RAILROAD COMMISSION OF TEXAS

PROPOSAL FOR DECISION

OIL AND GAS DOCKET NO. 04-0286186

APPLICATION OF SABLE ENVIRONMENTAL II, LLC, PURSUANT TO STATEWIDE RULE 8 FOR A PERMIT TO OPERATE A COMMERCIAL SEPARATION, RECLAMATION AND DISPOSAL FACILITY, APPLICATION CONTROL NOS. STF 059, R9 04-1301, PITS 011946 A/B/C, 011947 A/B/C, 011948 AND 011949, JIM WELLS COUNTY, TEXAS

04-0286186
PFD EXHIBIT A—Site Location
Applicant's Exhibit No. 8, Sheet 2-2

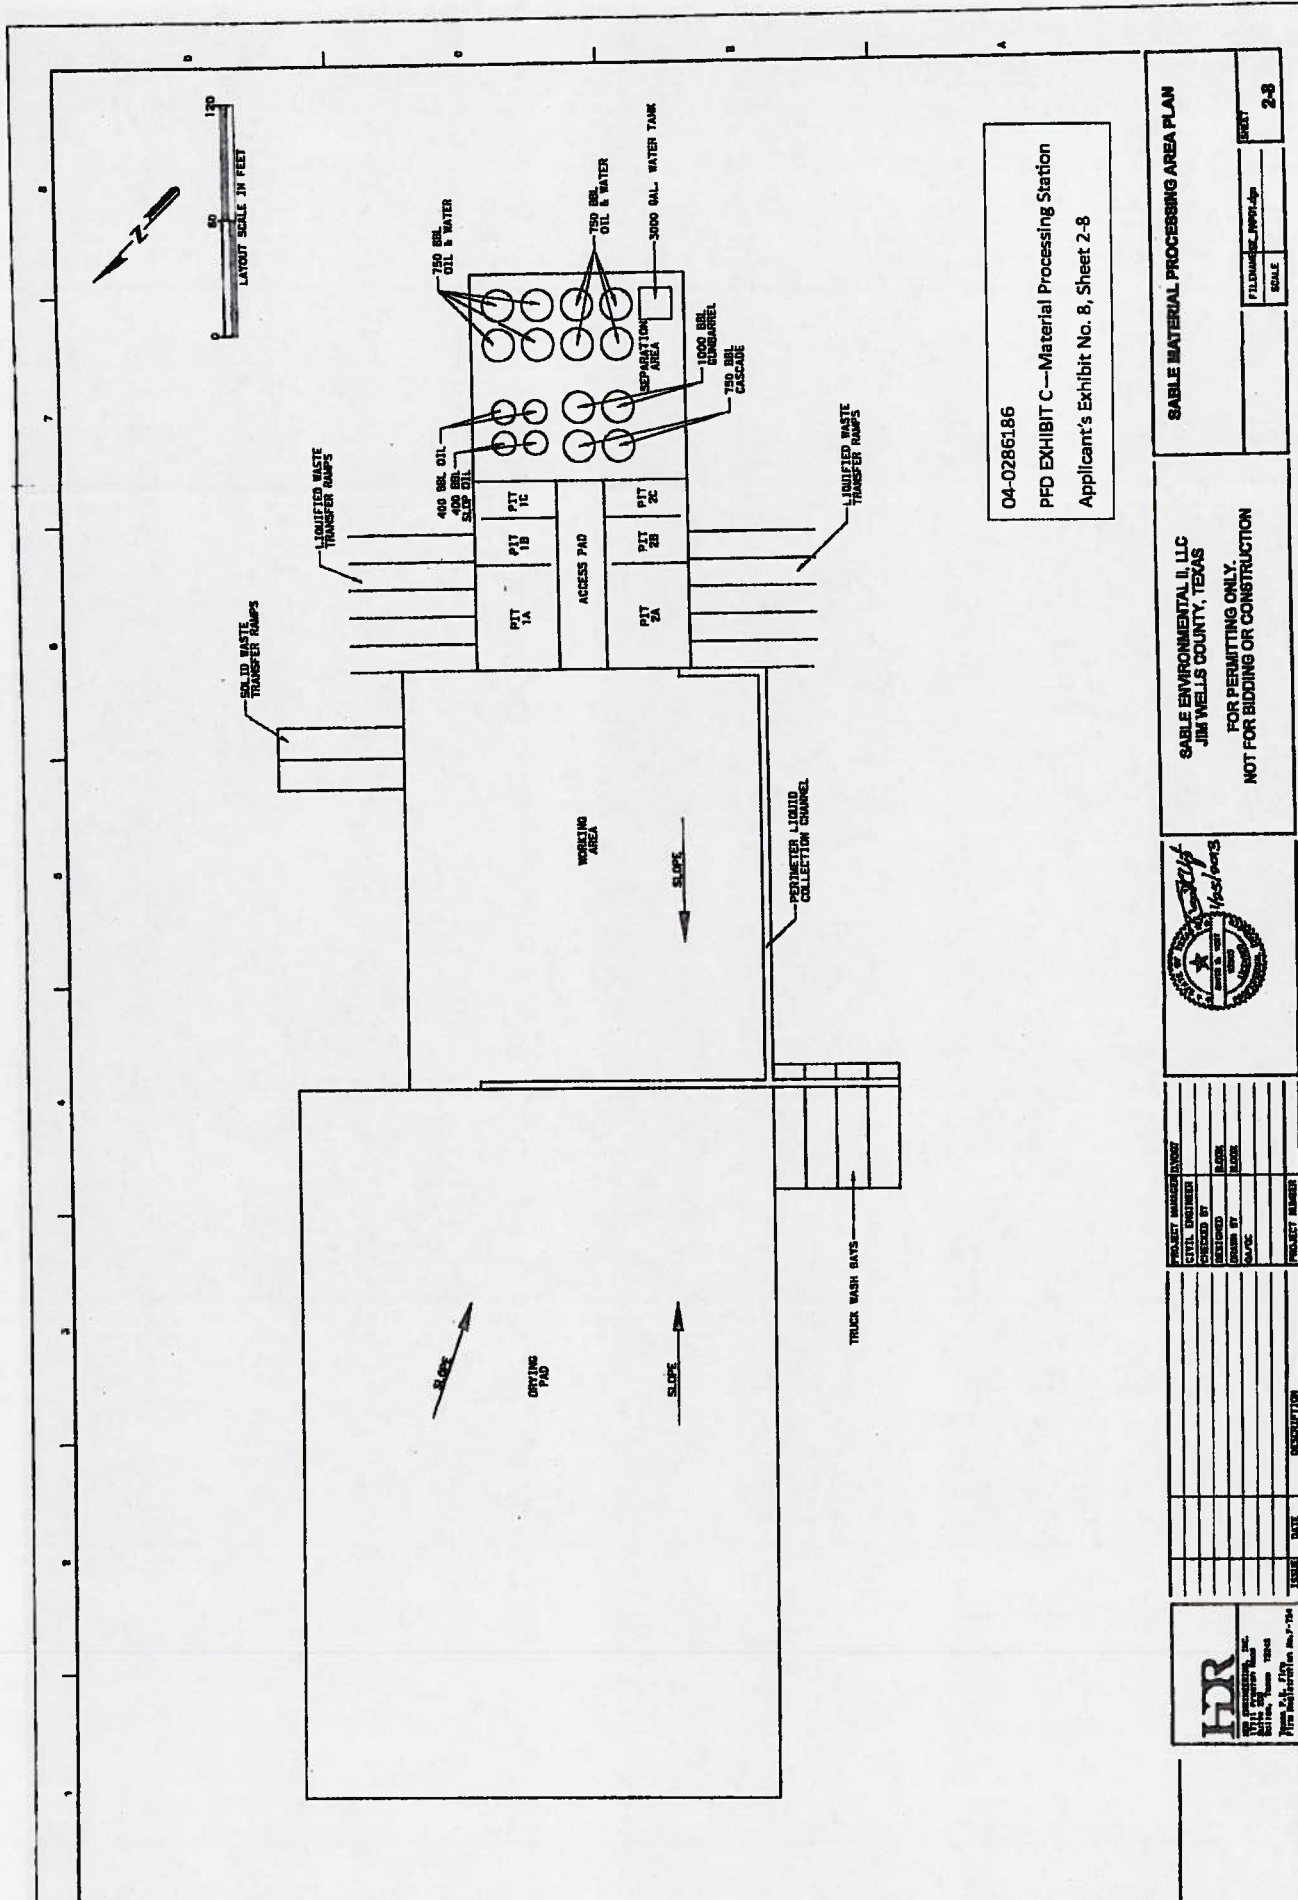
The applicant describes the proposed facility as located in a rural area.⁴ The site is on rolling terrain sloping toward the east and southeast. The location of the facility boundaries superimposed on a topographic map are shown on a site location map (See Exhibit A attached hereto⁵). The property outline exhibits a 'kite' shape. The site drains to Agua Dulce Creek, which is located about 4,000 feet to the north and east of the site, and flows to the southeast.

The natural elevation profile of the property (See Exhibit A) before onsite quarrying indicates a shallow ridge running from the northwest corner to the southeast; the surface topography dips away from the ridge to the northeast and southwest. The highest natural elevation is about 243 feet near the northwest corner of the tract, and the lowest natural elevation is about 218 feet on part of the north property line. Intermittent drainage pathways are evident along the southwest property line and adjacent to the north and northeast property lines.

The Protestants believe the proposed facility does not have sufficient capacity to store contact storm water that will be generated by a 25-year, 24-hour storm event (about 8.43 inches). In fact, the Protestants estimate the volume of a 4-inch rainfall event will be six times the volume of designed storage capacity of the facility for contact storm water. The Protestants' analysis included calculating precipitation volumes, facility surface areas, and estimating storage volumes of the collection channels and pits; it did not consider the storage capability of perimeter berms. Further, the Protestants believe anticipated precipitation from a 25-year, 24-hour event significantly underpredicts the amount of rainfall the area has received in a comparable period earlier this year. The Protestants also assert some precipitation runoff would flow onto the facility from the tract immediately to the west.

The proposed disposal pits will be constructed in a former caliche quarry. The Protestants testified that the quarry has at times contained varying amounts of accumulated water following rainfall events. The examiners note that the original land surface of the quarry is on a topographic high. Indeed, comparing the topographic and aerial photographic exhibits, the examiners note a positive correlation between topographic highs and other

quarries in the area.²³ The natural, unaltered topography does not appear to support the Protestants' contention that surface water will run-on to the property; in fact, the topographic exhibits indicate the opposite, especially in regards to the quarry area.

8. The disposal cells will be located in a former caliche quarry, which was located on an originally topographic high; there is no off-site drainage onto the disposal area.
